**UMMC PROJECT NO. 409-007
FIRE PROTECTION CENTRAL CORE
UNIVERSITY OF MISSISSIPPI MEDICAL CENTER
JACKSON, MISSISSIPPI**

Addendum No. 1

August 5, 2026

This addendum forms a part of the contract documents and modifies the original plans and specifications dated June 12, 2026.

FP401

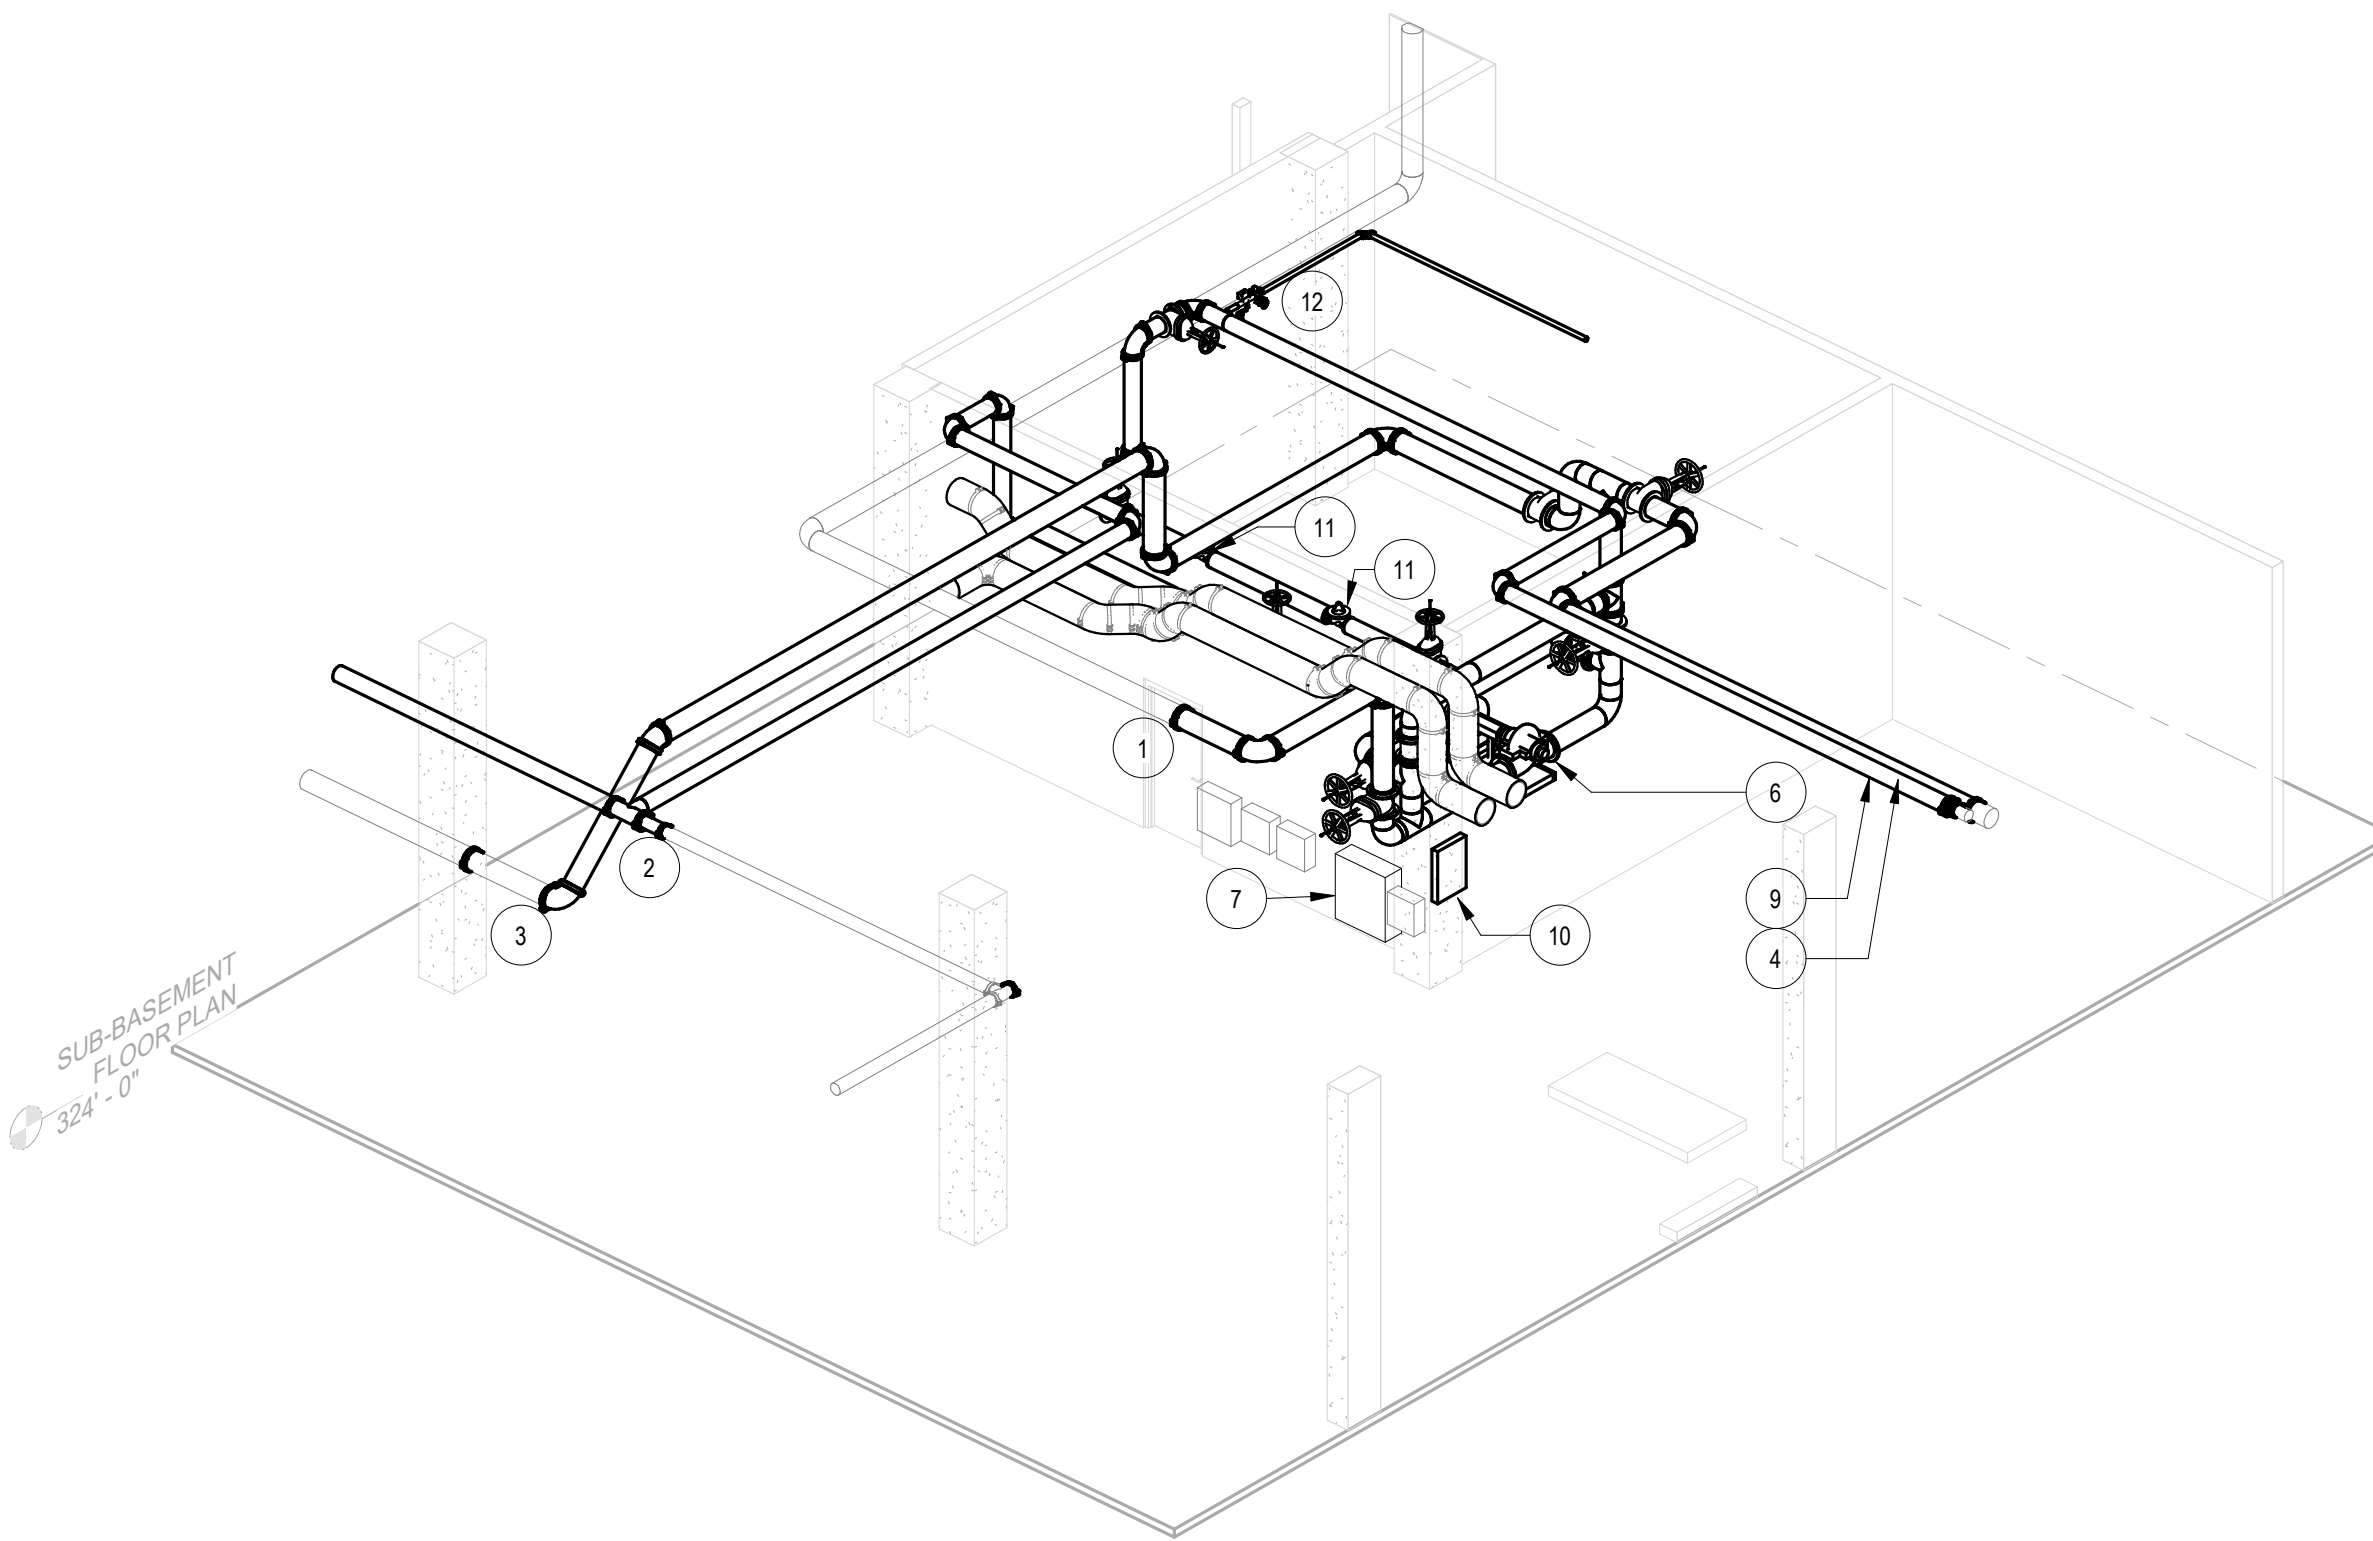
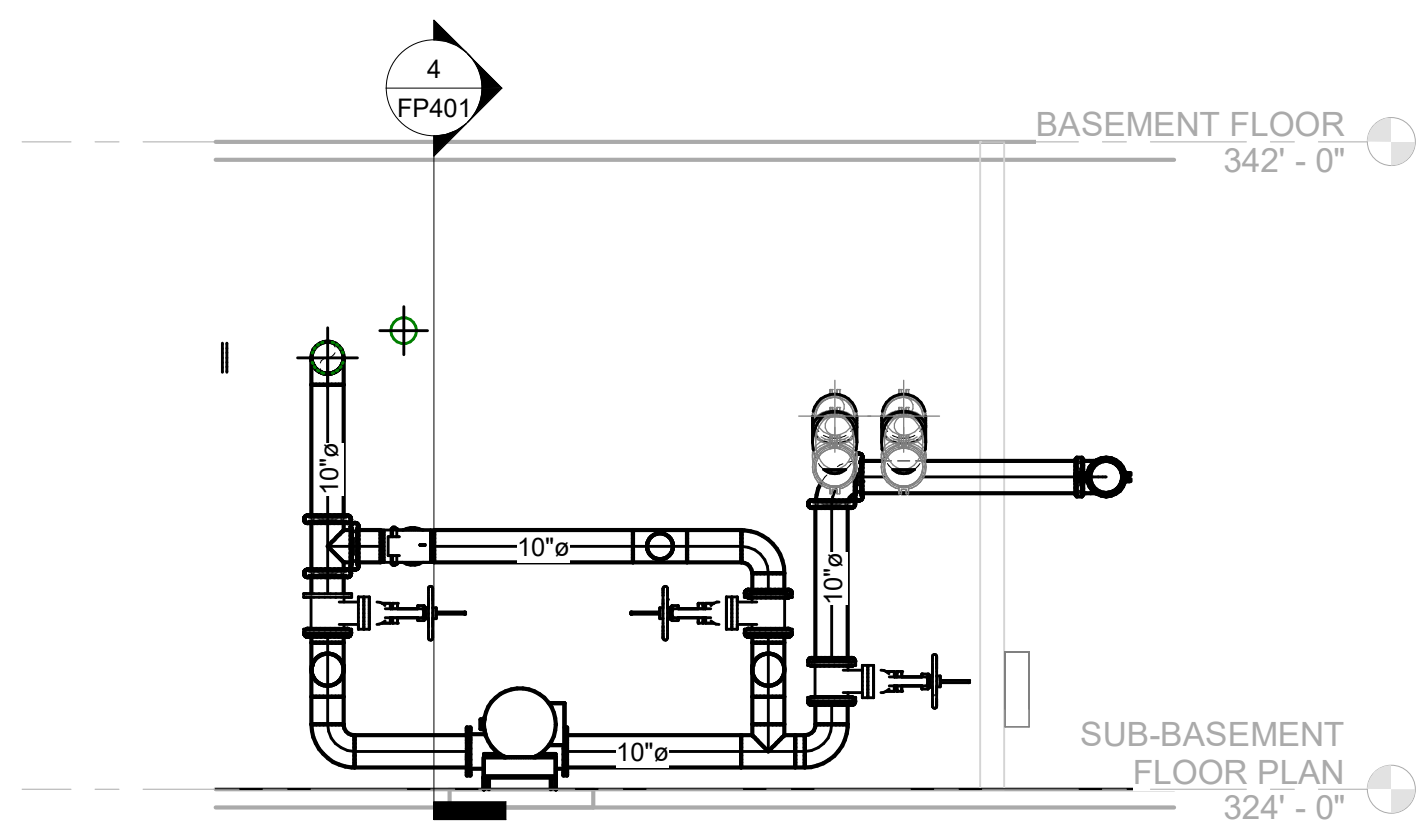
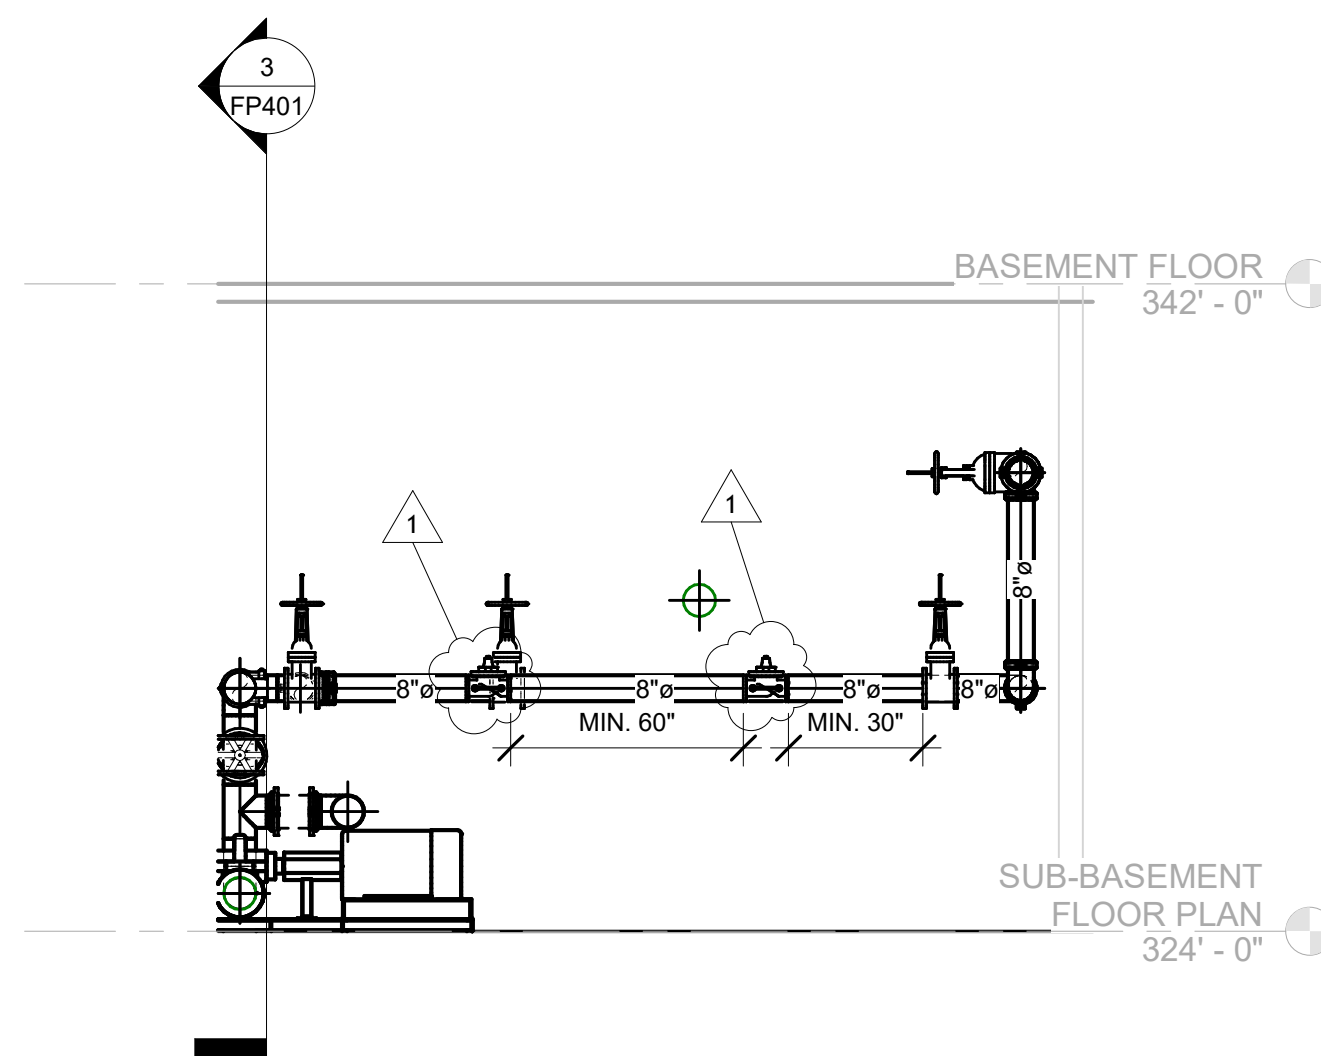
- 1. New sprinkler zone scope boundary added.
- E. Sheet FP401, Fire Pump Enlargement Plans New Work
 - 1. New pressure relief piping removed.
 - 2. PRVs and connected piping increased in size from 6" to 8".
